Public Works Standard Drawings Subcommittee Meeting

Monday, May 24, 2021 Microsoft Teams

Division 5000: Wastewater Collection

CAST-IN-PLACE '04 5030 *Section II Standard Drawings as of October 2004. Reference number only has been updated for Fifth

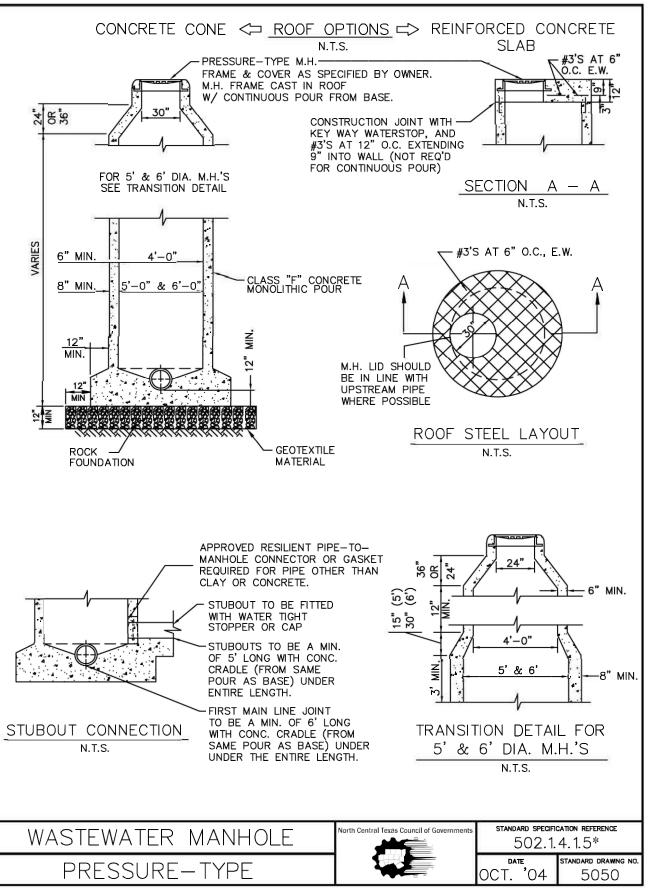
Add note that this is just one alternative material – other materials could be used, per approval of by city engineer

Show flat top with standard and bolt down frame and cover.

24" opening at the bottom is no longer sufficient, it should be 30".

Monolithic pour is heavy burden for the industry

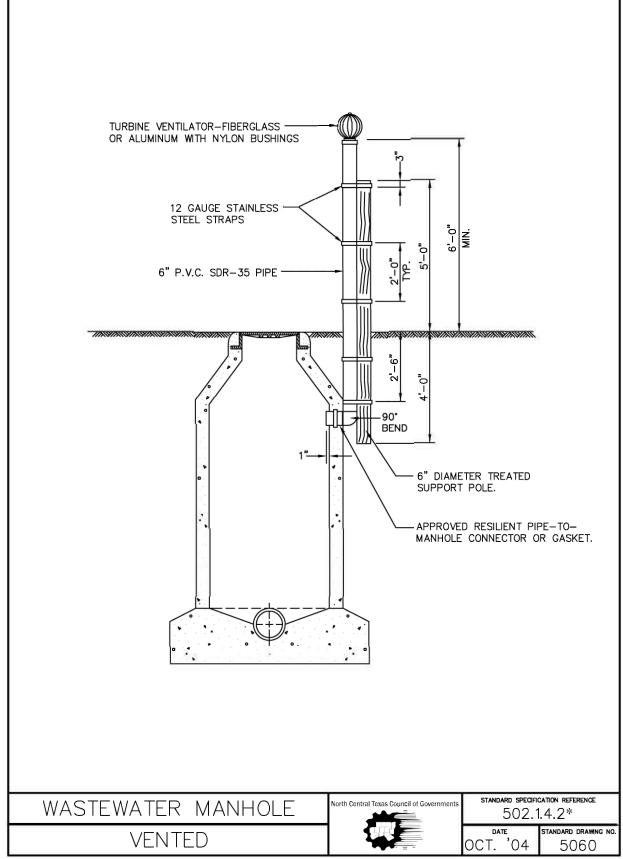
An access chamber with clean outs is referenced in the specifications but is missing from the drawing.

TCEQ 217 rule should be added as a note for the height outlet above the floodplain.

Add a dimension for a minimum burial vent pipe.

Add embedment or flowable fill to add stability.

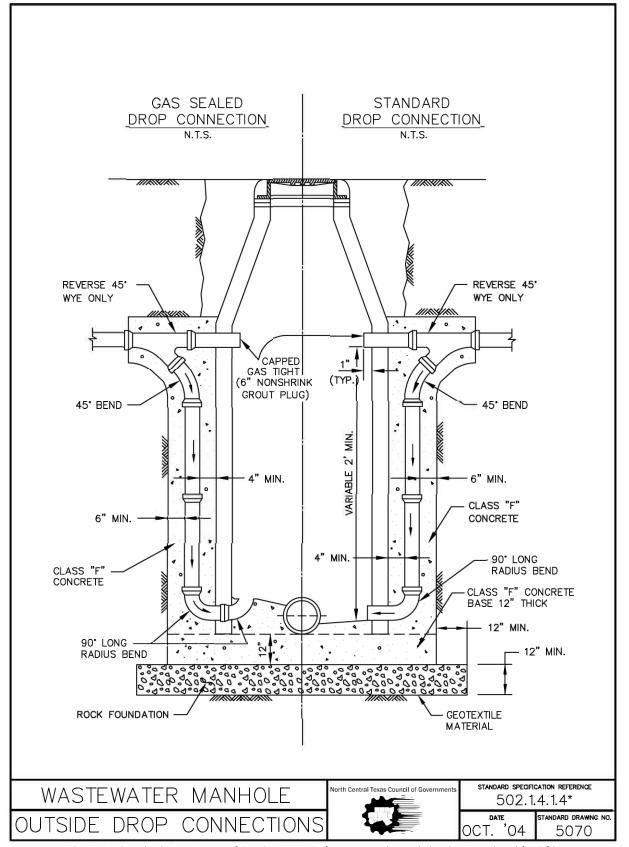
For straight pipe that comes in at the top, remove arrow and leave open on the right side.

The detail starts to show how to build a manhole but it should reference back to the manhole detail for barrel and cone.

Add note,
"Extend as
directed by
owner" and
consider
Lewisville
detail to
show this.

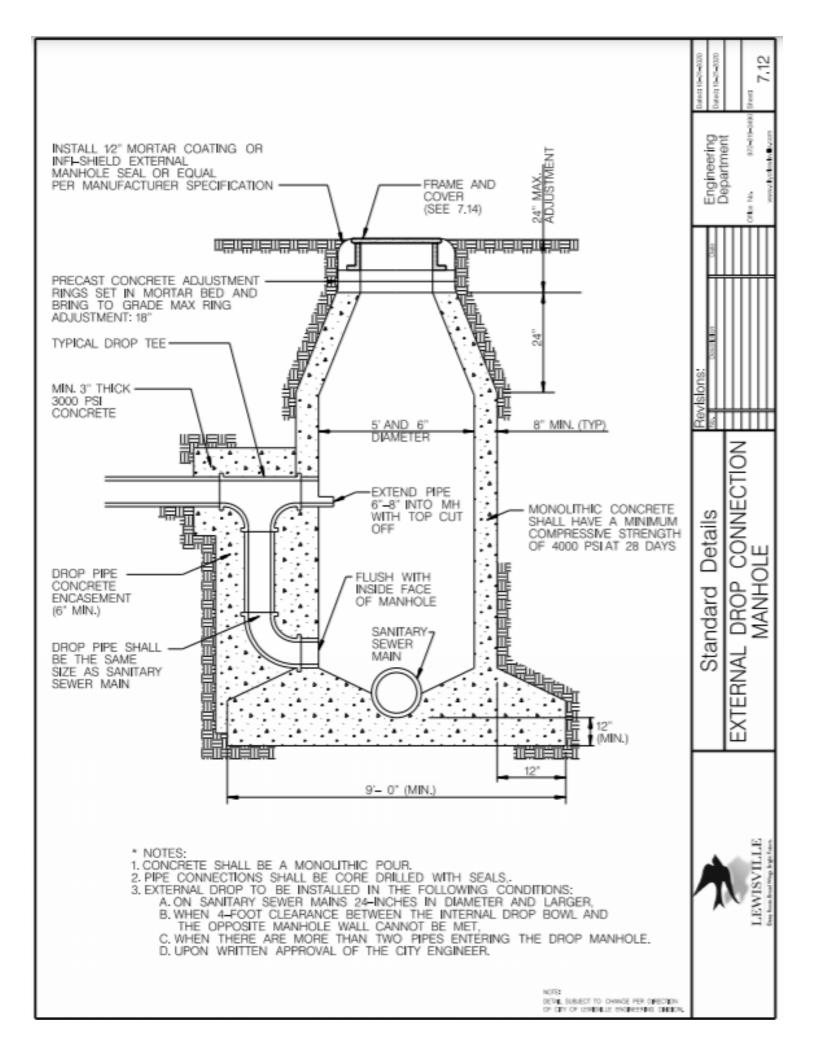
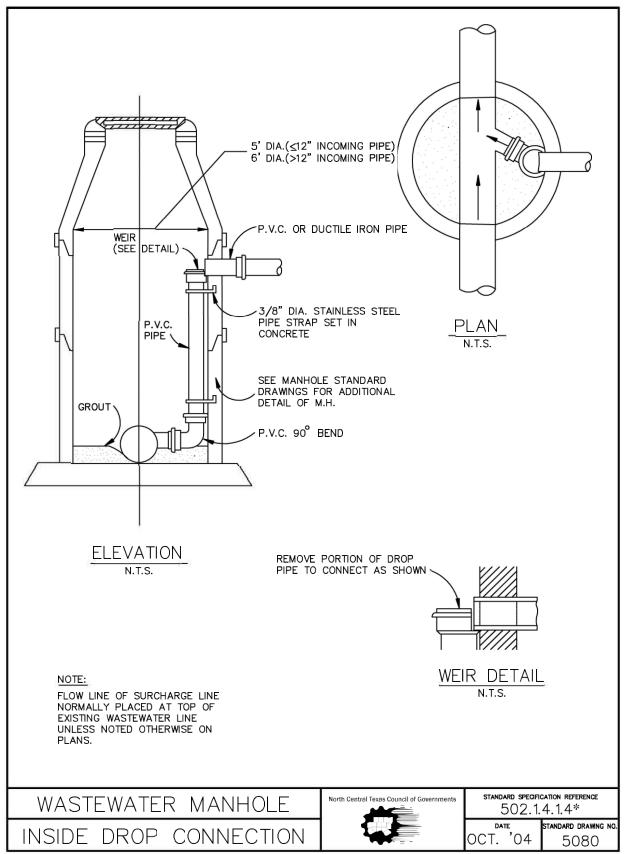
Remove the ball used as a connection piece.

Show support (straps) 3'-4' apart minimum, reference Lewisville details.

Add note, "4' maximum of spacing, 2 straps minimum,"

As shown in the previous detail, resilient collar should surround the incoming pipe on drop.

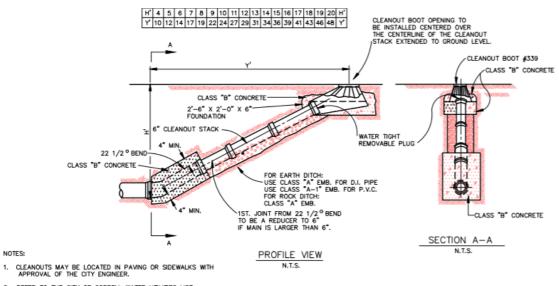
Replace
with a detail
for a
wastewater
access
detail.
Reference
Dallas
Water
Utilities and
Lewisville
detail.

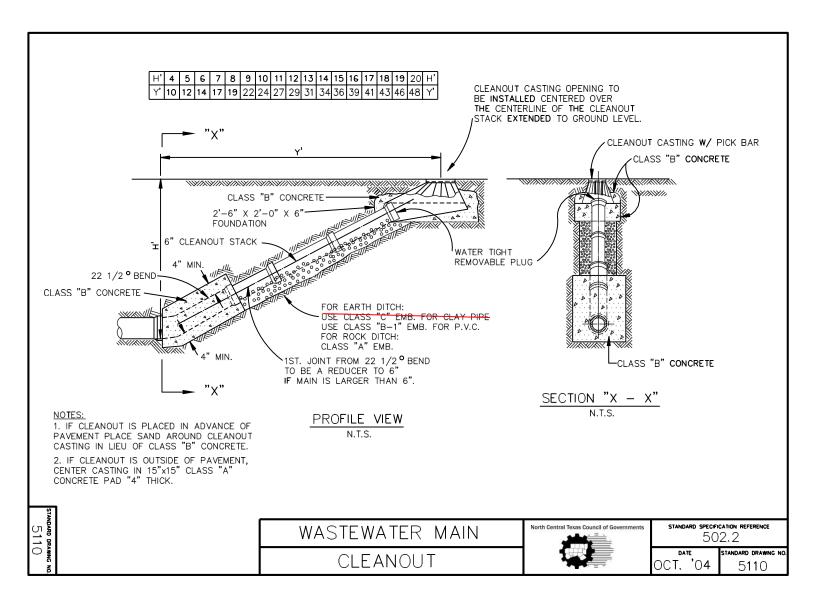
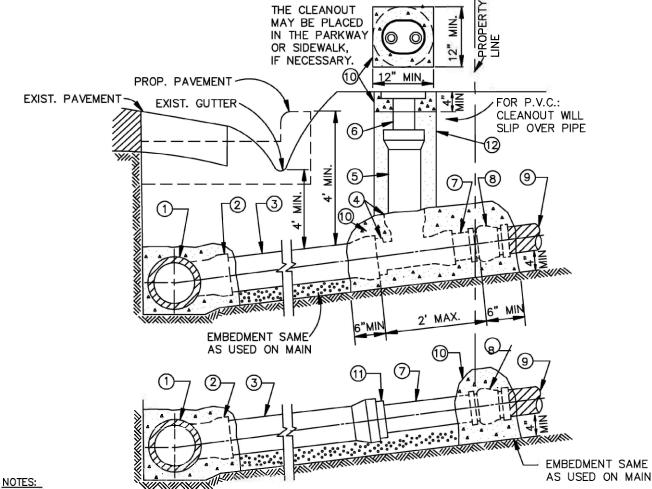
Add note, "Only to be used with express consent of the owner."

- (1) WASTEWATER MAIN
- 4" WYE or tap
- (3.) 4" WASTEWATER LAT. (LENGTH VARIES)
- (4.) 4" X 4" TEE OR WYE AS REQ'D. BY OWNER.
- (5.) 4" STACK (LENGTH VARIES)
- (6.) 4" WASTEWATER LAT. CLEANOUT CASTING

standard drawing no. 5120

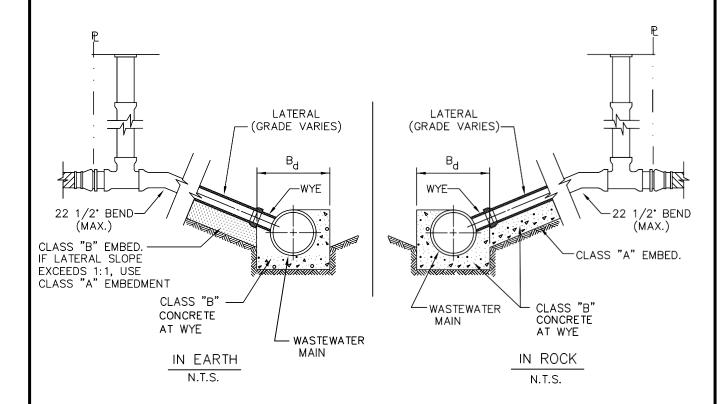
Add note,
"Minimum
9'
separation
from water
service."

WASTEWATER LATERAL CONNECTIONS

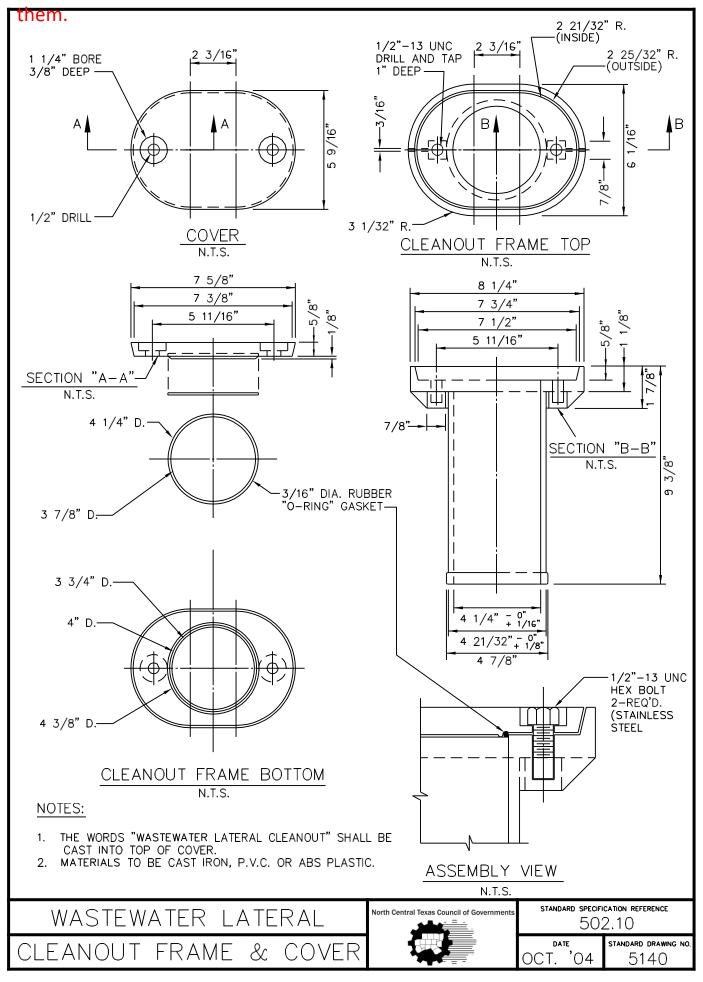
Send this detail to Bass & Hays and ask if they use it or if it's relevant to

The wastewater lateral details should be cleaned up, it's unnecessary to have 5 drawings.

However, they need to stay consistent with specification 502.10.4.1 on page 502-28. Mathew will provide feedback outside of meeting.

STANDARD DRAWING NO 5150

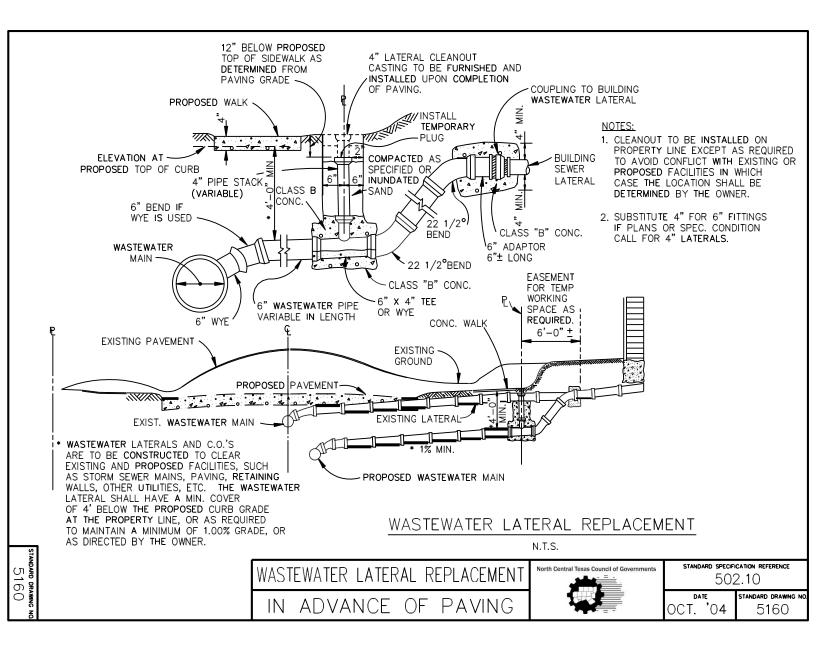
The wastewater lateral details should be cleaned up, it's unnecessary to have 5 drawings. However, they need to stay consistent with specification 502.10.4.1 on page 502-28. Mathew will provide feedback outside of meeting.

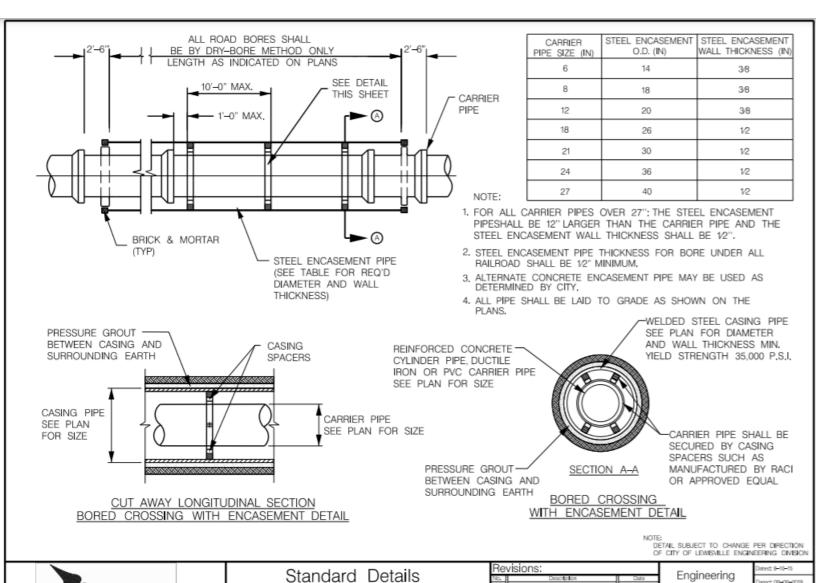
Add a note pointed to the cone area, "Removal depth limited to 2' above ground or as directed by owner."
